## **Addendum 1 – October 13, 2025**

**RFB Specification No. ES25-0092F**

**CENTRAL WASTEWATER TREATMENT PLANT BSST TRANSFER PUMP  
REPLACEMENT PROJECT**

CITY OF TACOMA  
ENVIRONMENTAL SERVICES DEPARTMENT  
CENTRAL WASTEWATER TREATMENT PLANT  
BSST TRANSFER PUMP REPLACEMENT PROJECT  
RCM-17425A INTERNAL ELEVATION

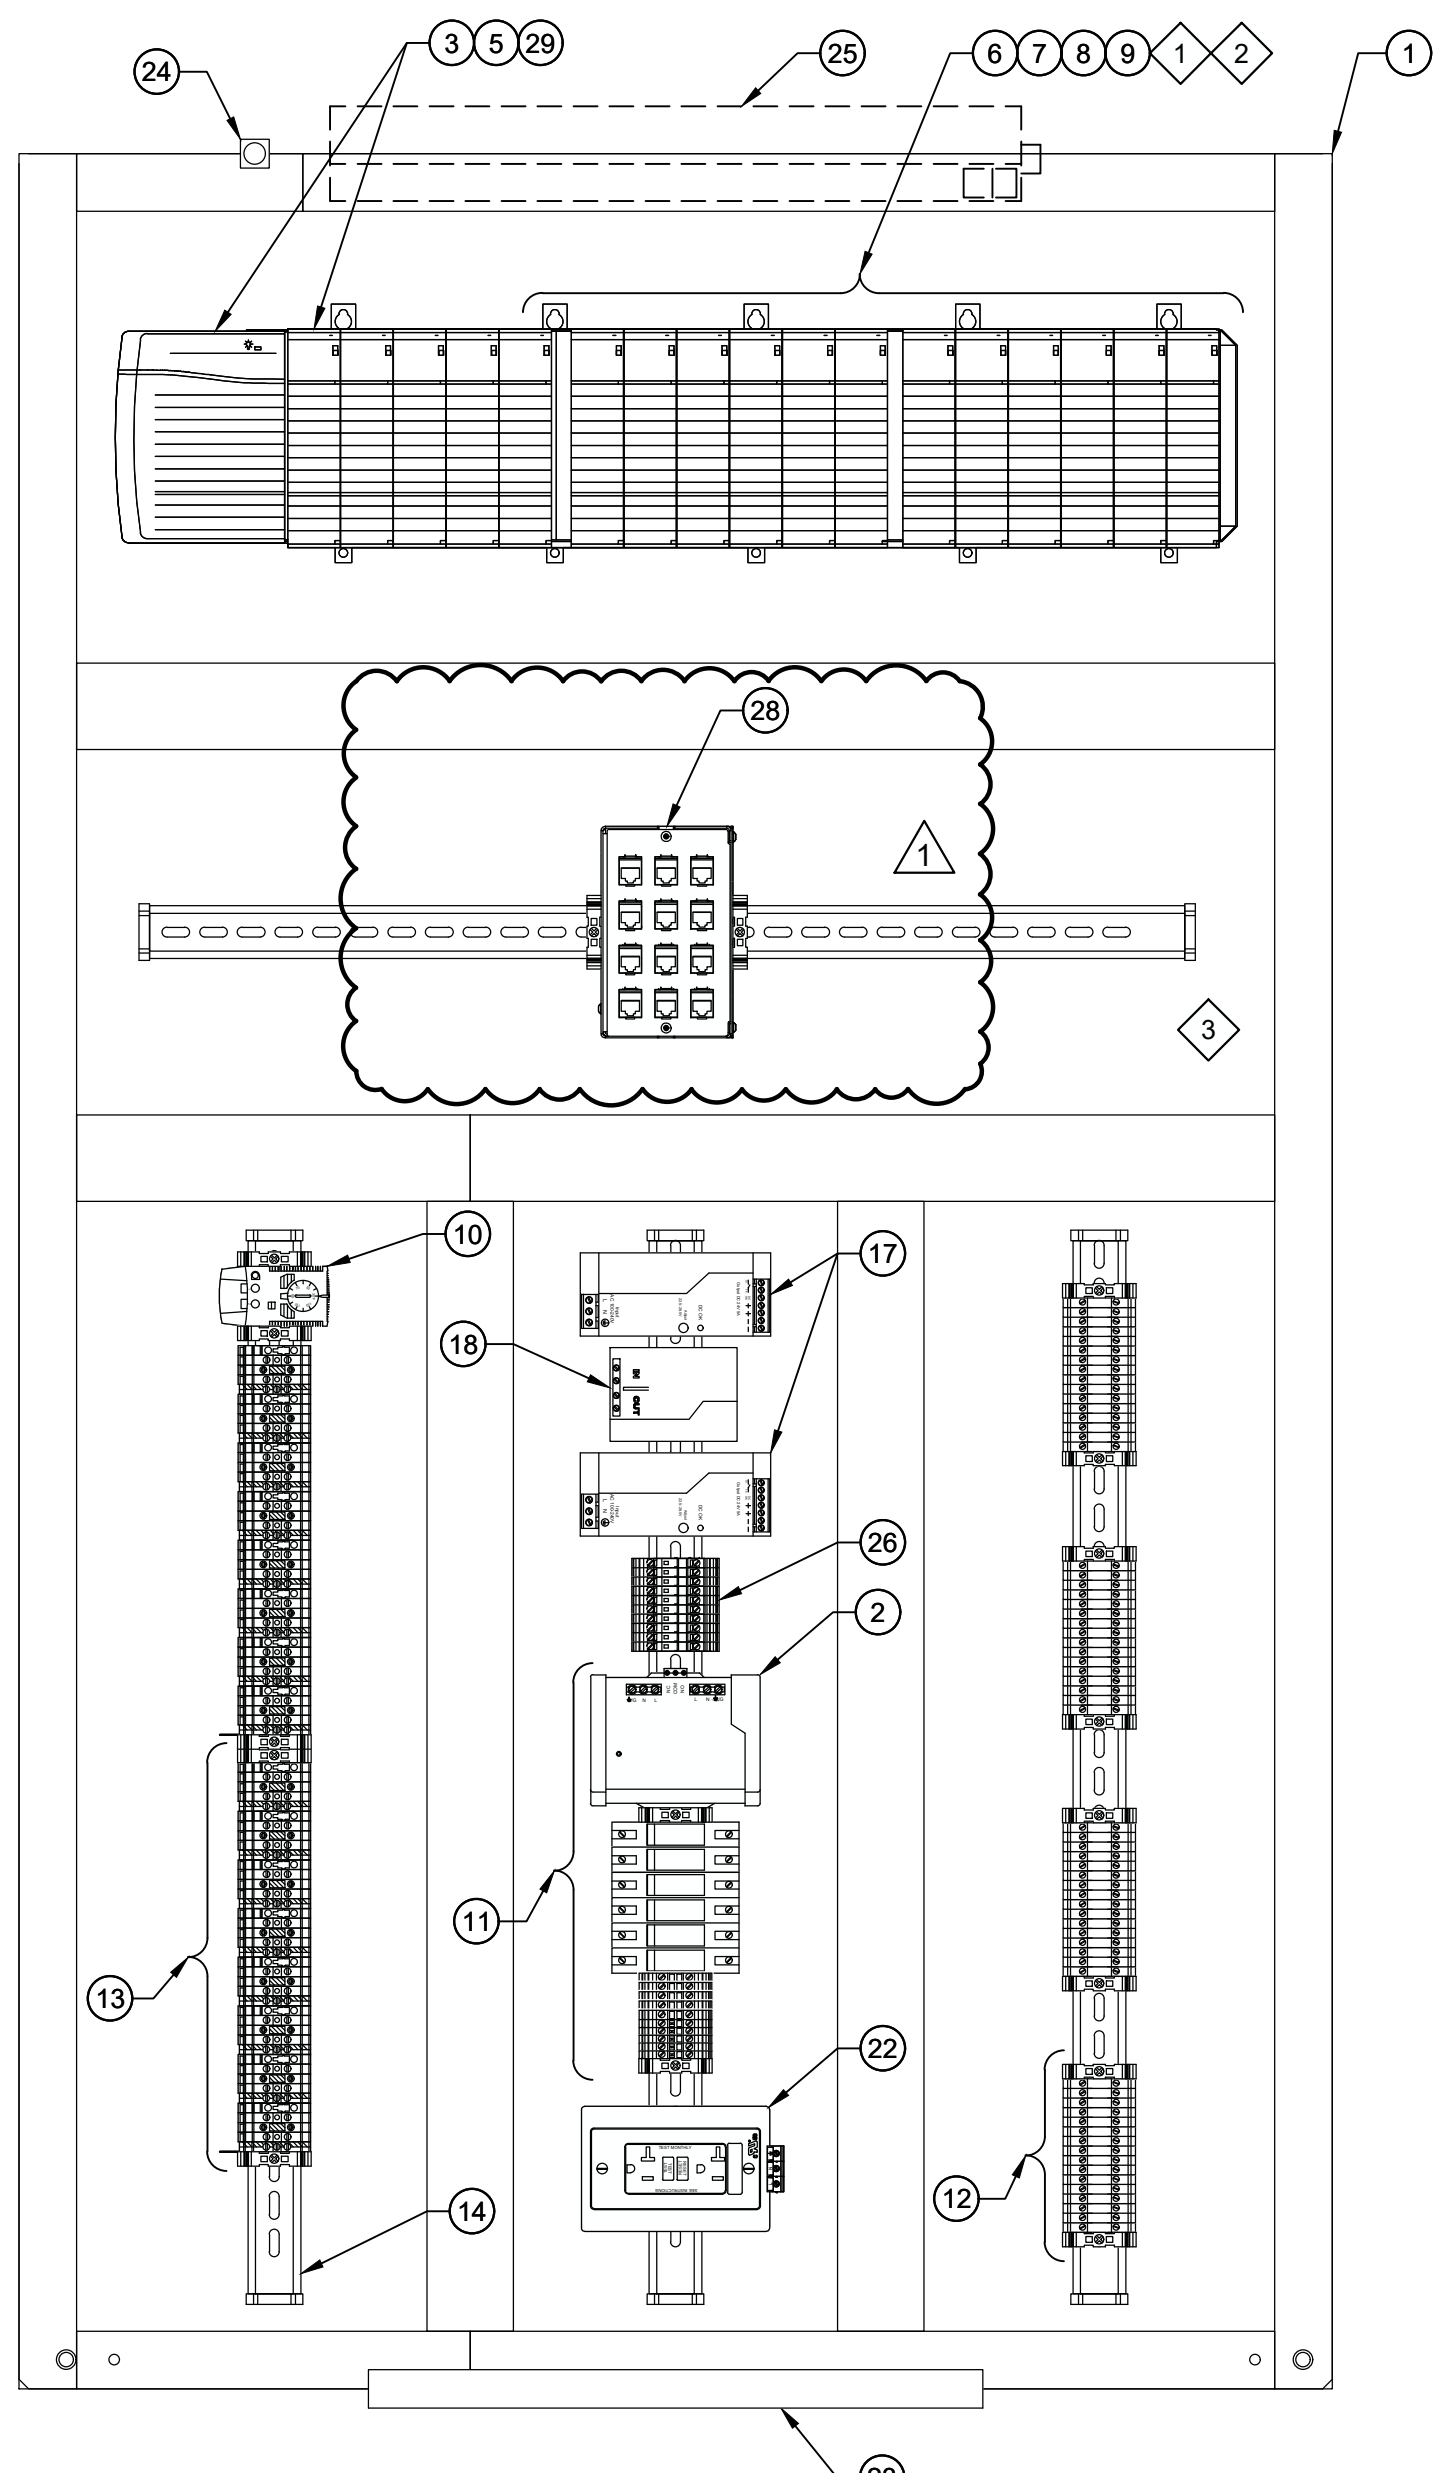
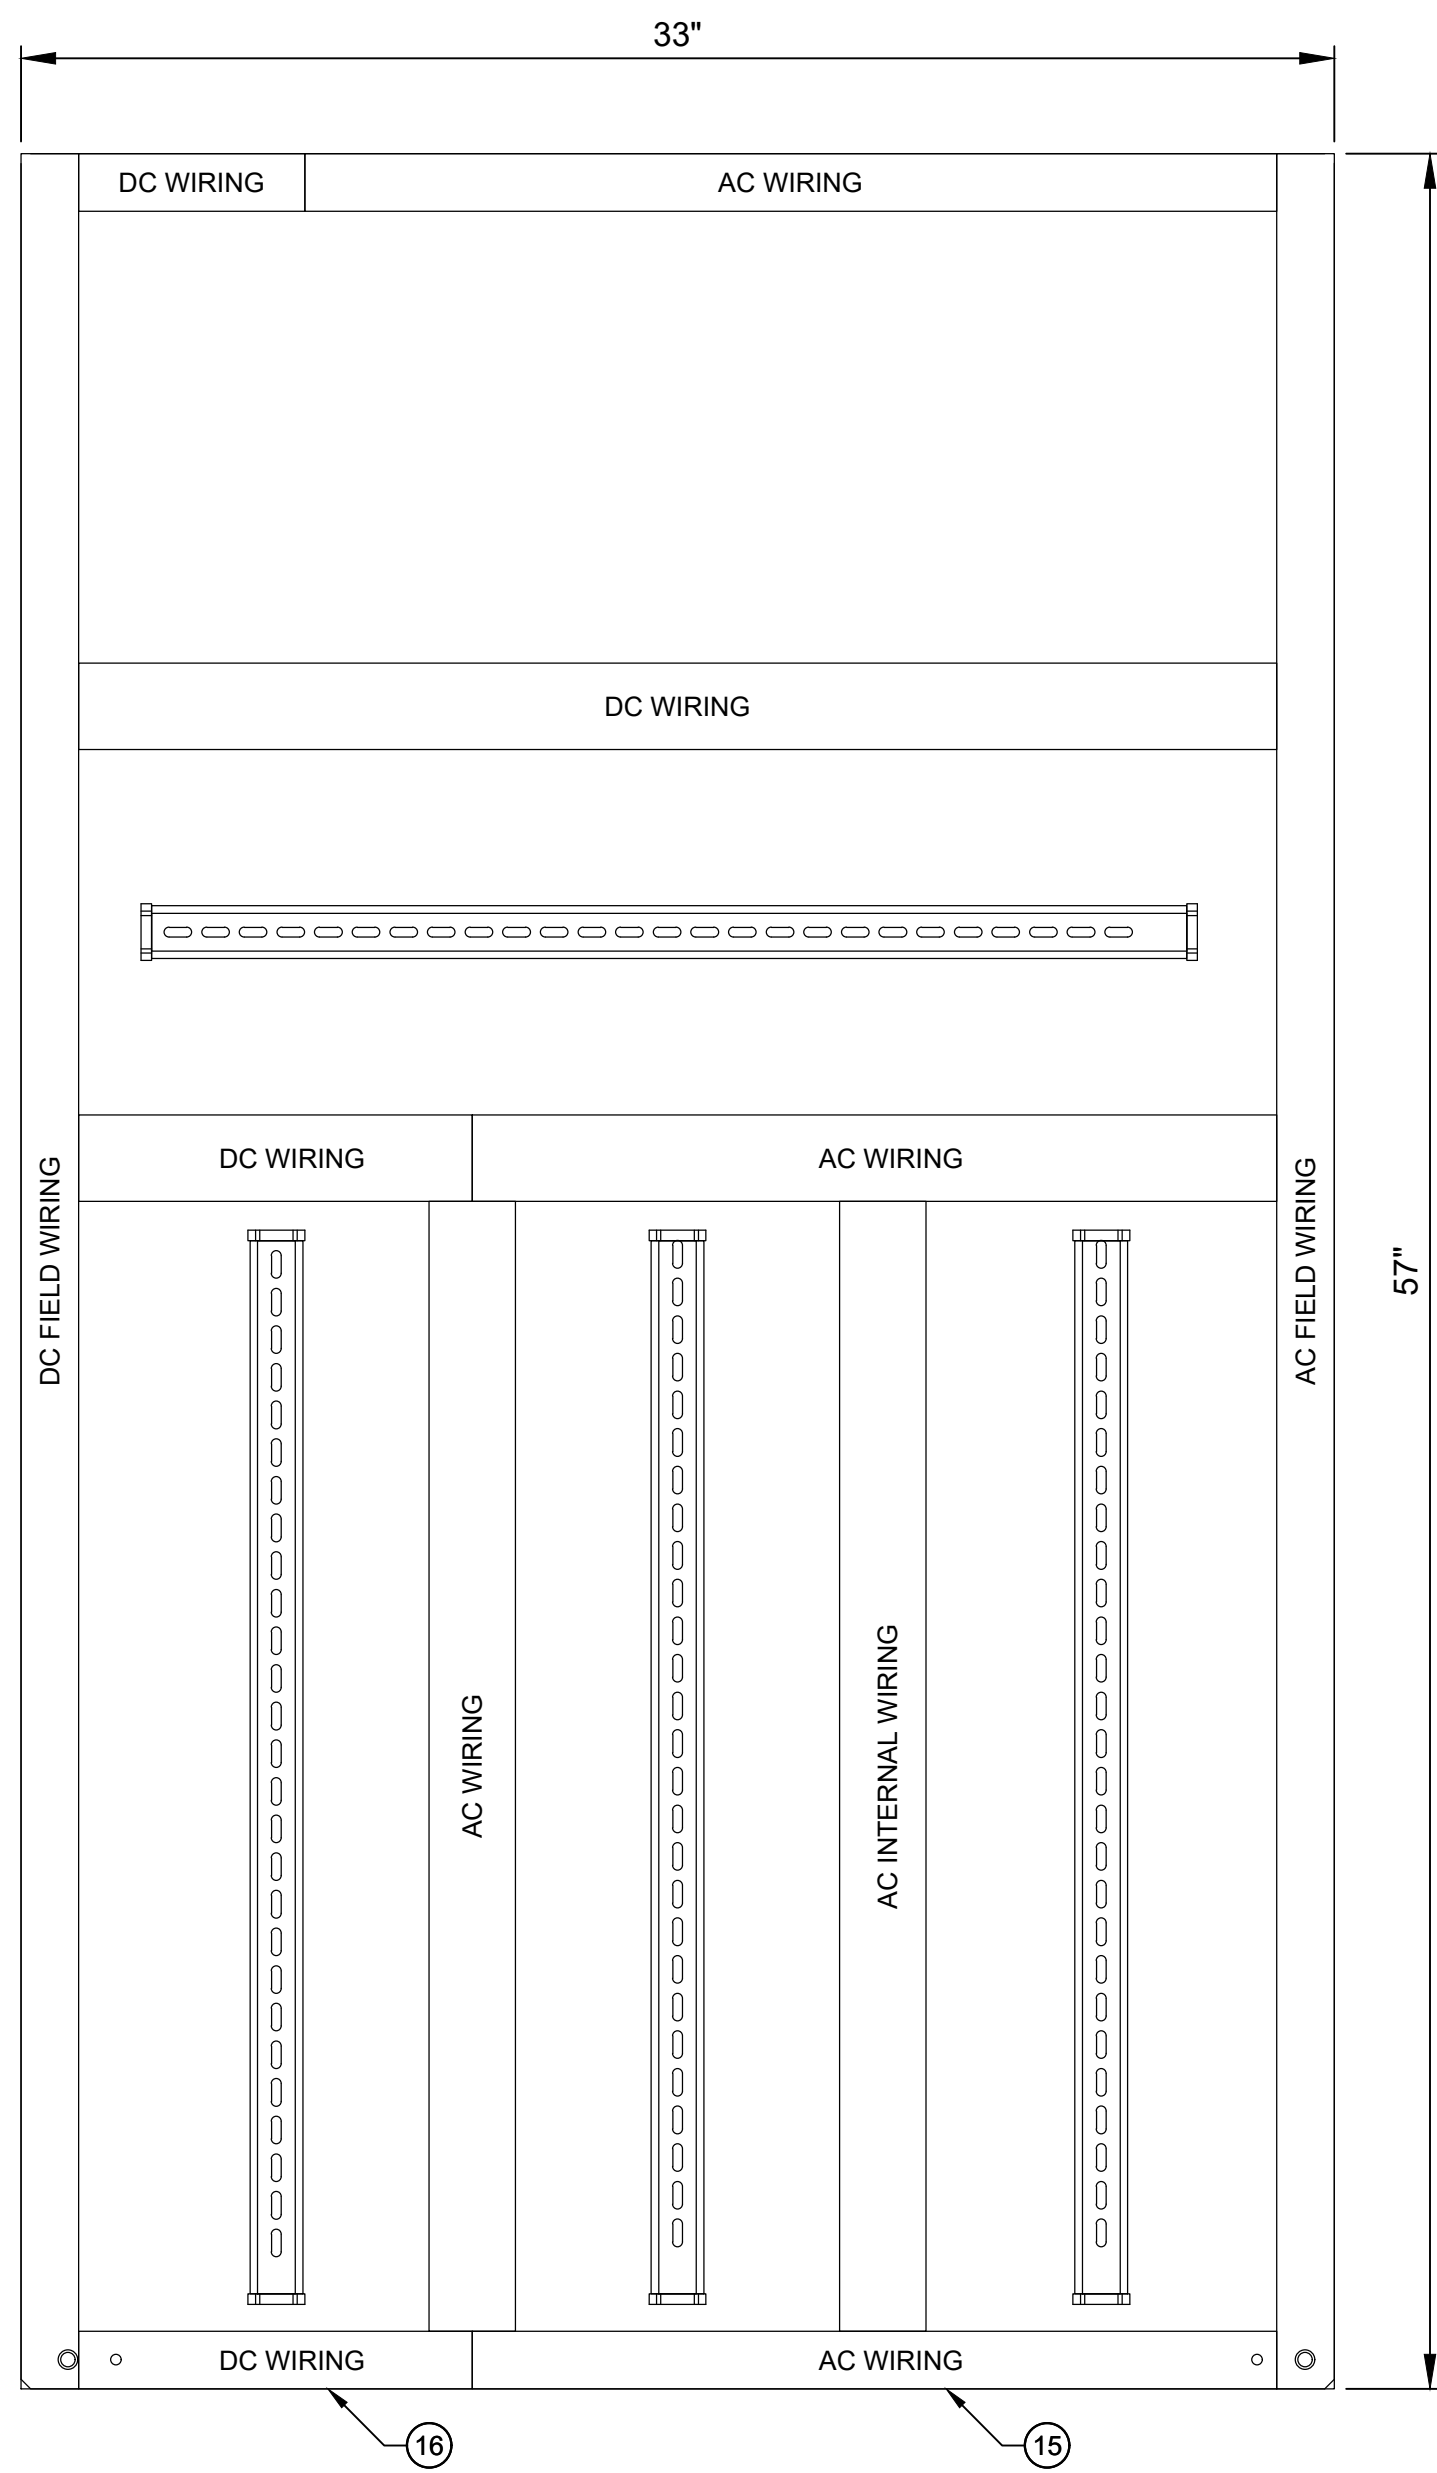
#### **Change No. 1 - Revision to Drawing I04, Sheet 46**

Remove reference to Profibus Equipment and replace the existing plan sheet with updated version.
